Re: Chino Administrative Order on Consent (AOC)
Feasibility Study for the Smelter Tailings Soils Investigation Unit

Freeport-McMoRan Chino Mines Company (Chino) submits under separate cover the *Feasibility Study (FS) for the Smelter Tailings Soils Investigation Unit (STSIU)* under the Chino Administrative Order on Consent (AOC). The FS has been prepared and submitted in accordance with Appendix A, Section 2.7.7 of the AOC. Chino previously submitted a draft *FS* for the STSIU, in a letter dated February 19, 2025, to the New Mexico Environment Department (NMED). NMED opened a public review and comment period on March 7, 2025, ending April 12, 2025, for stakeholders as well as the public. Chino provided an overview and a detailed presentation of the *FS* to the Community Work Group and NMED on May 14, 2024, and March 11, 2025, respectively. The *STSIU FS* has been revised to address comments provided by the NMED, including comments received from the public review period in a letter dated May 23, 2025. Chino requested an extension for submitting the revised FS, in a letter dated July 14, 2025, to accommodate updating the 2015 pH monitoring study results referenced in the *FS*, with

FIGURE 3-2a

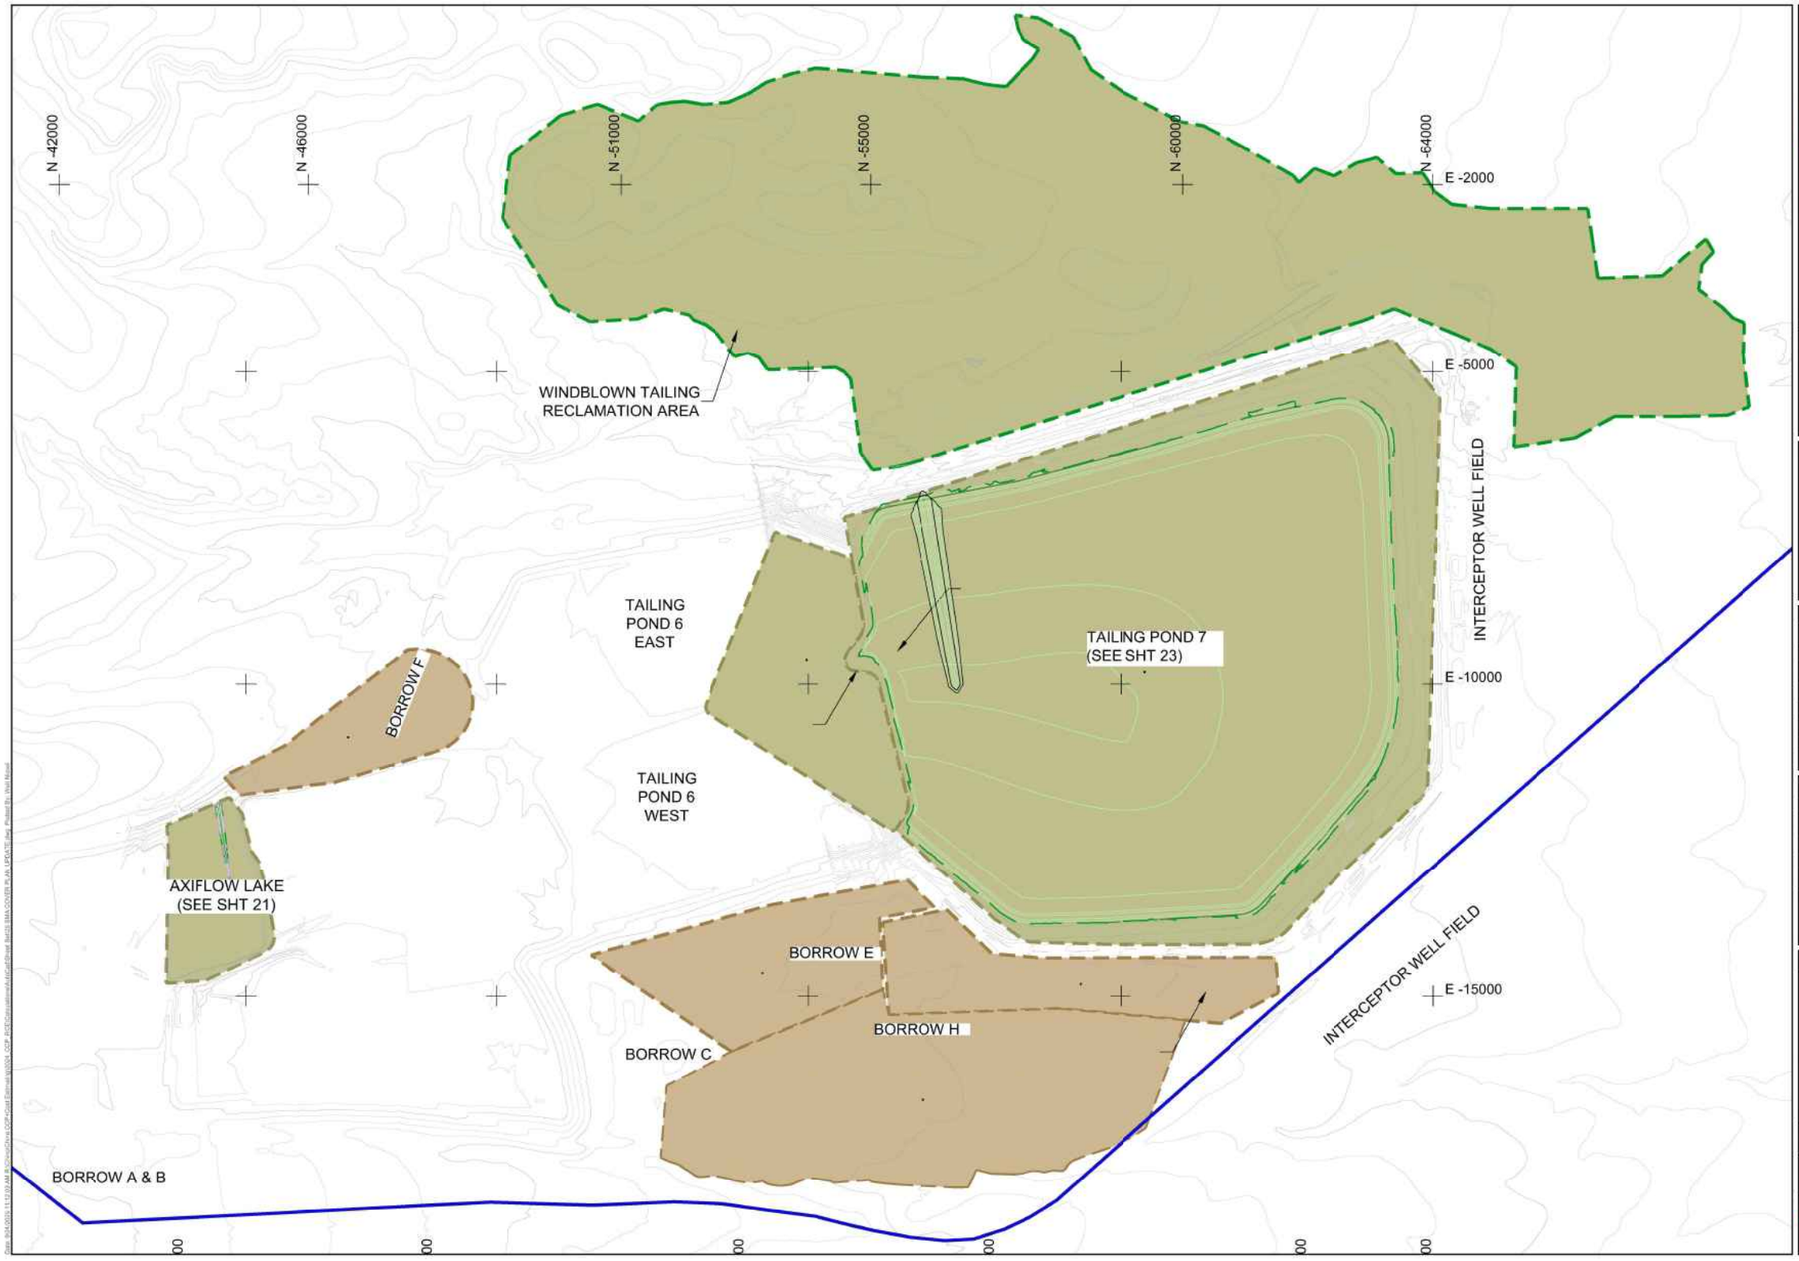
2	NMED GWQB	3.1; p. 19	The windblown tailings areas are shown in Figures 3-2a and 3-2b. Please ensure that the extent of the windblown tailings areas that will be removed from consideration in the AOC and placed into the CCP is up-to-date and accurate. Please provide acreage of the areas to be considered under the CCP on each figure and clearly identify areas within and outside of the CCP acreage that have pCu < 5 and meet the habitat quality parameters (i.e. either good rangeland or good wildlife habitat) that would require the area to be considered for potential remedial action in the FS. Those areas that would have needed to be considered for potential remediation under the FS but are being moved in the CCP should be clearly identified in the figures.	An update to the FS, consistent with the current revisions to the CCP anticipated to be finalized in mid-2026 following NMED review, is now provided in the revised FS, including changing Figures 3-2a and 3-2b, to identify current and projected future windblown tailing areas that will be addressed under the CCP, with notation of number of acres for these areas in the summary for the report. Figures 8-1 and 8-2 identify acres that would be considered for potential remedial action under the FS, including areas targeted for reclamation under the CCP. Though shown on the maps, the flat rocky areas overlapping the recent and projected windblown tailing area will not be remediated under the AOC (note: Drainage A will still be monitored). Also, note that the borrow pit area in Figures 8-1 and 8-2 was refined based on more accurate information, which reduced flat rocky acres for remediation in Figure 8-1 by removing a 41 acre polygon (HE317) that has a pCu that averages above 4.98. Costs for pCu-related alternatives were also updated for the removal of HE317.

FIGURE 4-2

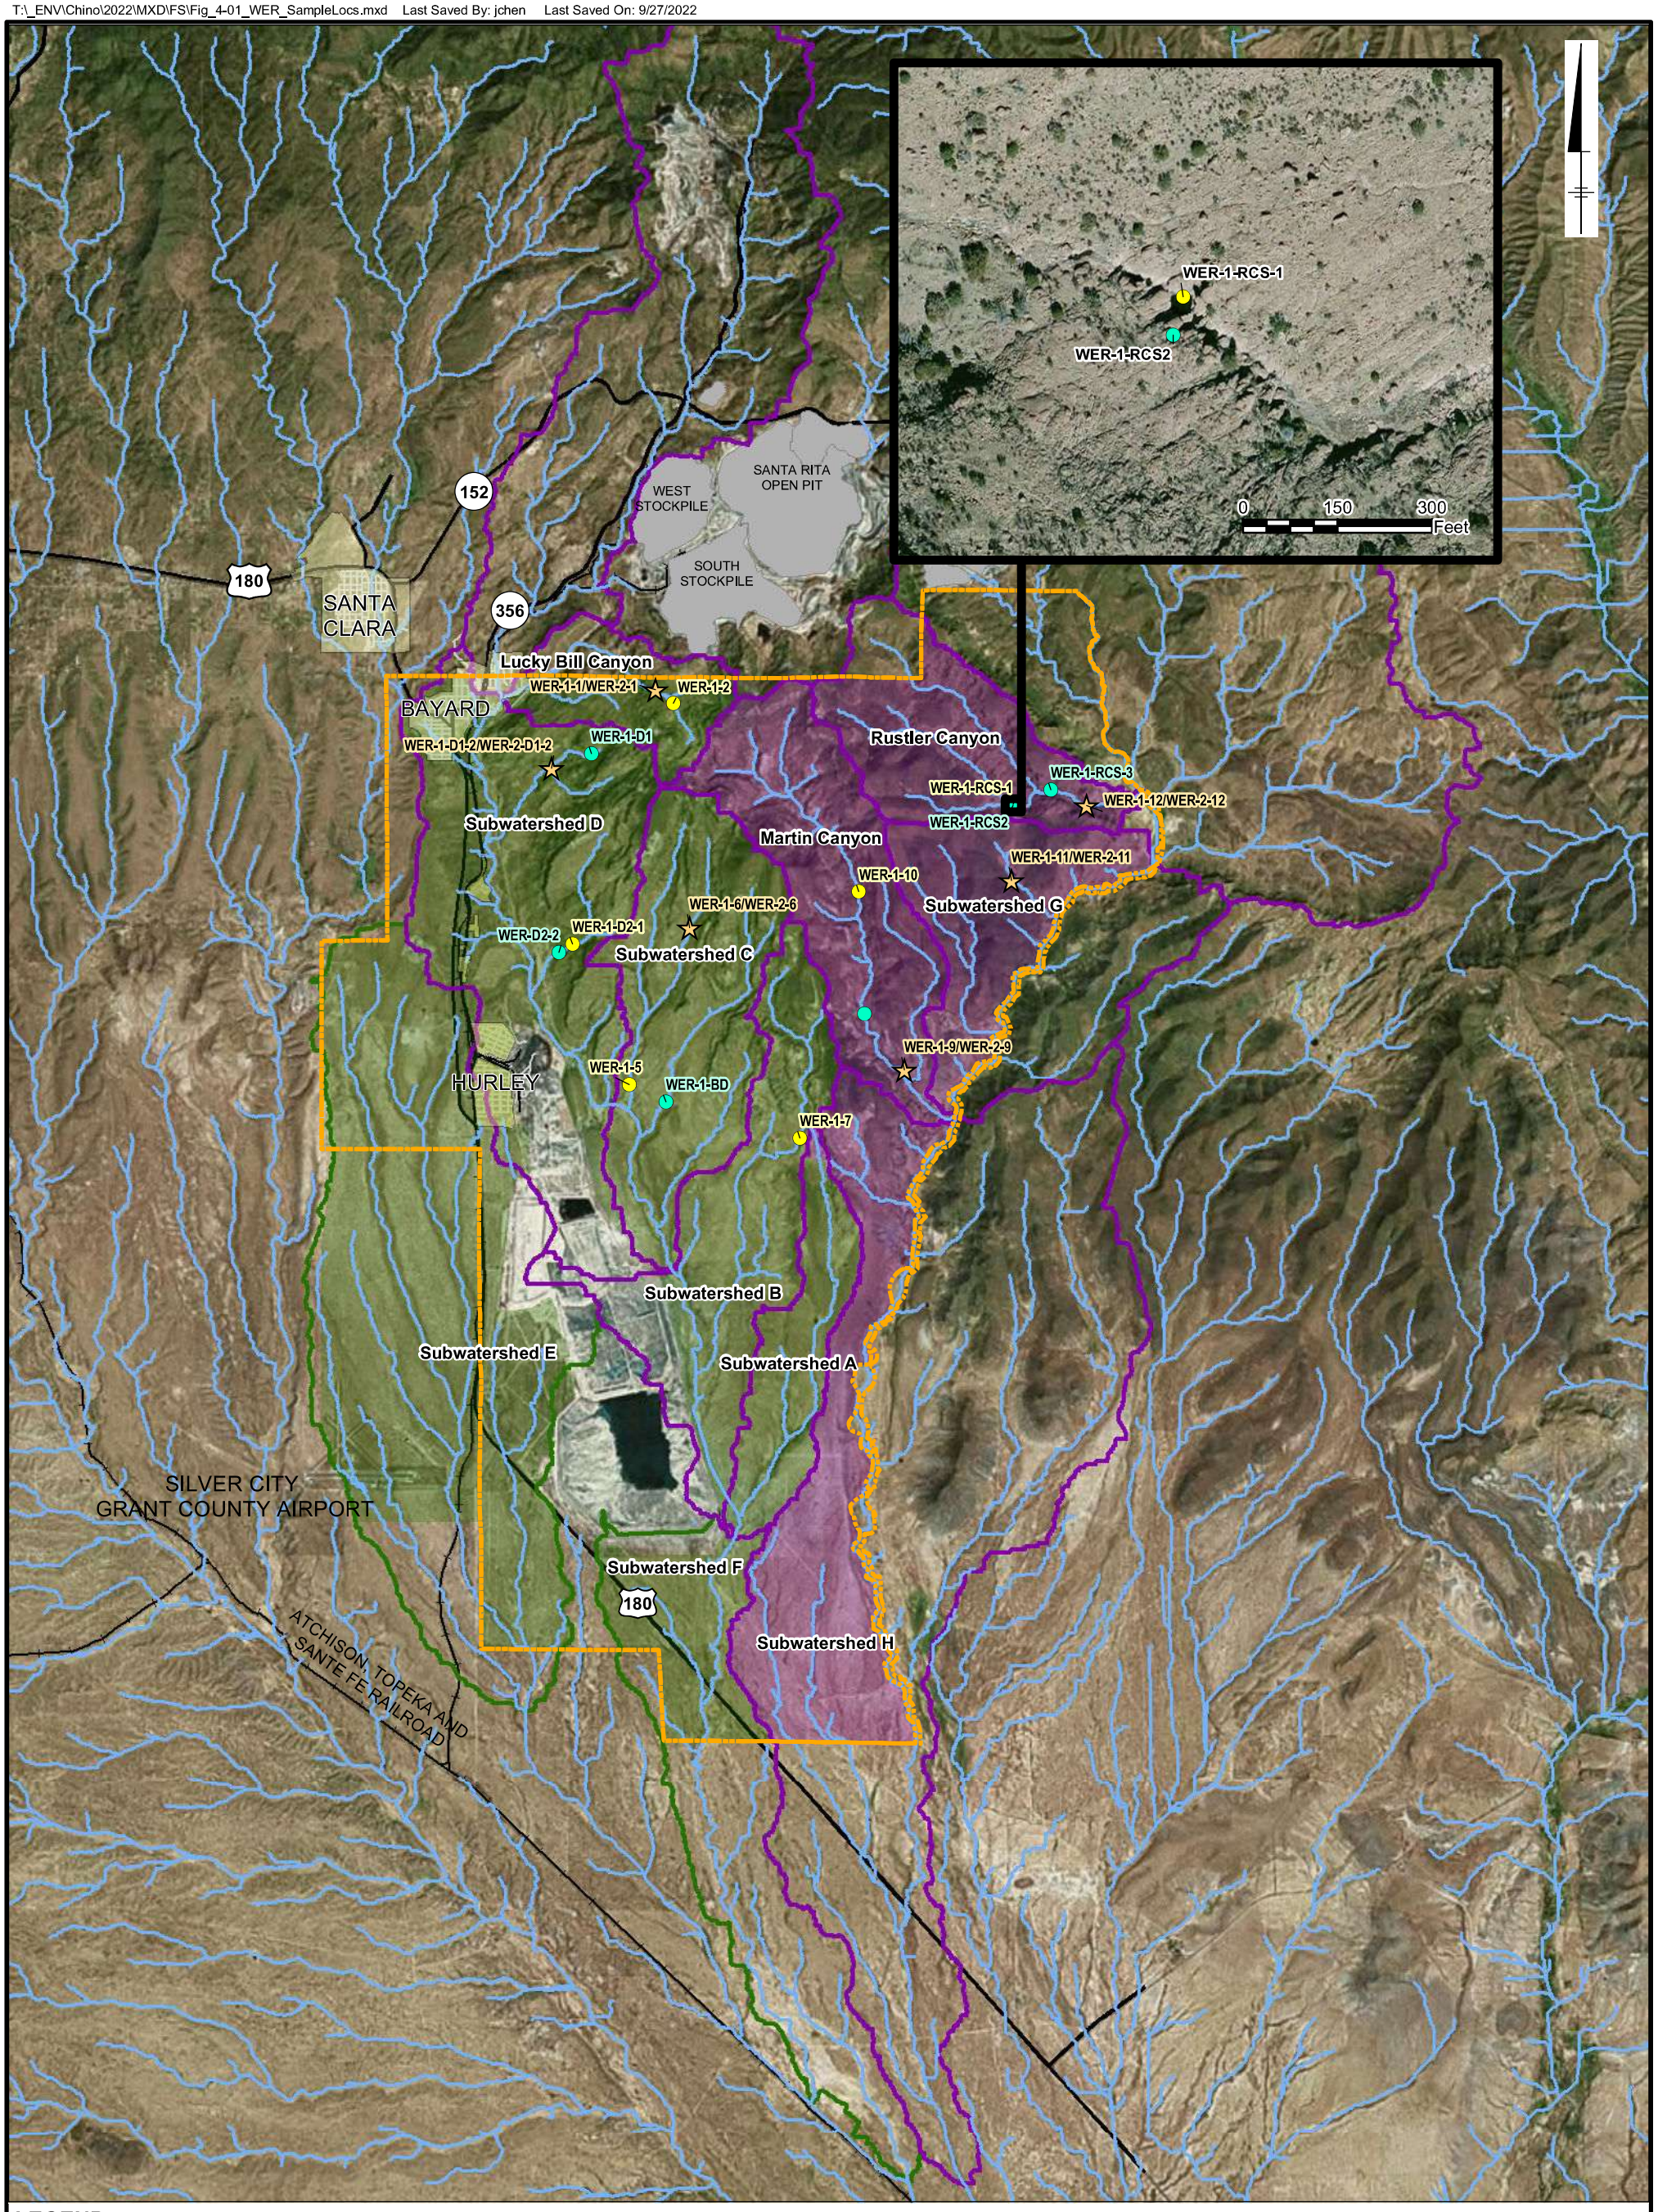
SWQB-3	NMED SWQB	Figures 4-2, 4-3, and 4-4	Figures 4-2, 4-3, and 4-4 exclude SWOTS identified in 20.6.4.808 and 20.6.4.809 NMAC and the STSIU Surface Waters Map, CHINO MINES SITE-SPECIFIC COOPER CRITERIA MAP, Exhibit A, (included below) SWOTS within the Smelter Tailing Soils Investigation Unit Lands at the Chino Mines Company. Please revise Figures 4-2, 4-3, and 4- 4 to include all SWOTS or provide a discussion of why they are excluded	Figure 4-2 represents these SWOTS correctly as ephemeral and non-ephemeral drainages, except it does not include mainstem Lampbright Draw from Rustler Canyon confluence down to Highway 180 as a SWOT, and it shows Drainage G and a tributary to Bayard Canyon in Lucky Bill Canyon as ephemeral. Although these two drainages are likely ephemeral, they were not investigated as part of the UAA or included as ephemeral in NMAC, and therefore they were changed to non-ephemeral. Note that, Bayard and Lucky Bill main drainages are officially addressed under the Hanover/Whitewater Creek IU. Lampbright Draw also was changed to a non-ephemeral drainage. Figure 4-3 and 4-4 were updated similar to Figure 4-2 and corrected. The criteria comparison tables will also be updated and corrected to match the Figure 4-3 and 4-4 maps.
